CITY OF MANITOWOC

From: Paul Braun, City Planner

Re: State Highway 42 Reconstruction Project (Washington Street & Calumet Avenue)

TYPICAL SECTIONS

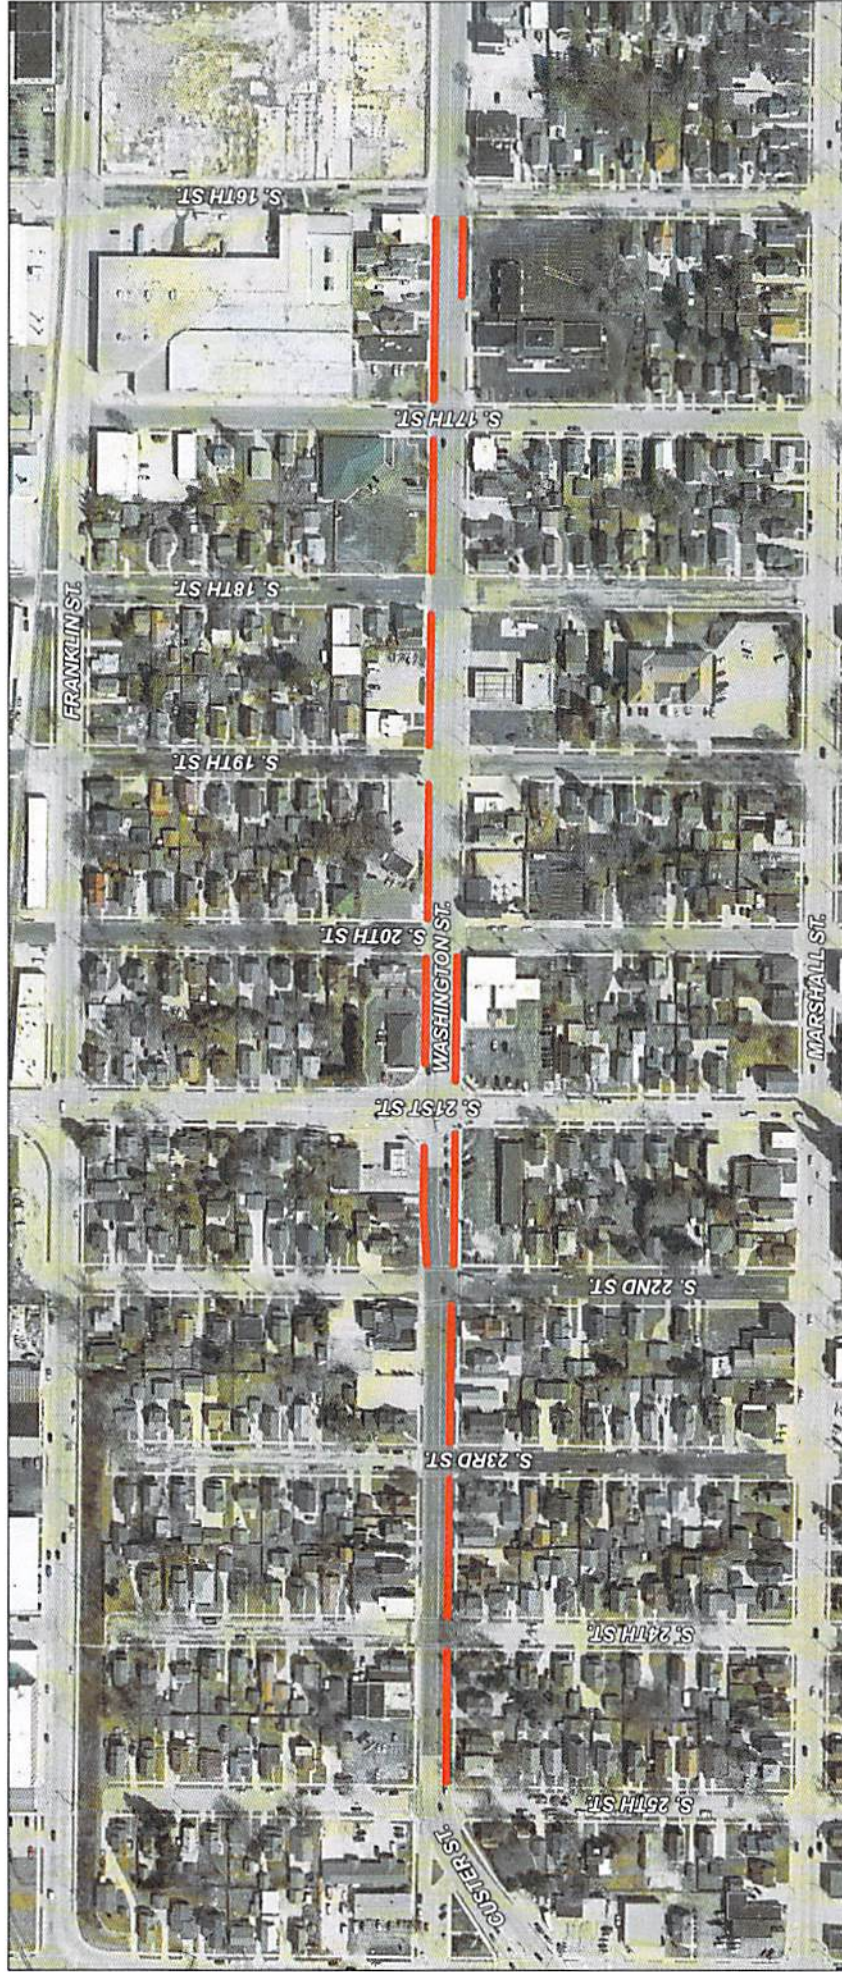
Community Development and Public Infrastructure staff have discussed the on-street parking design from S. 16th to S. 25th Street and are recommending this section be designed without on-street parking. The major reasons for the recommendation include public safety for pedestrians and vehicles, improved site vision triangles, decrease in accidents, and consistency of the center line and parking lanes along the corridor. Attached are the cross sections, the first page is the current design, the second page would be the design if no parking lanes are included. The last map attached shows the existing on-street parking conditions.
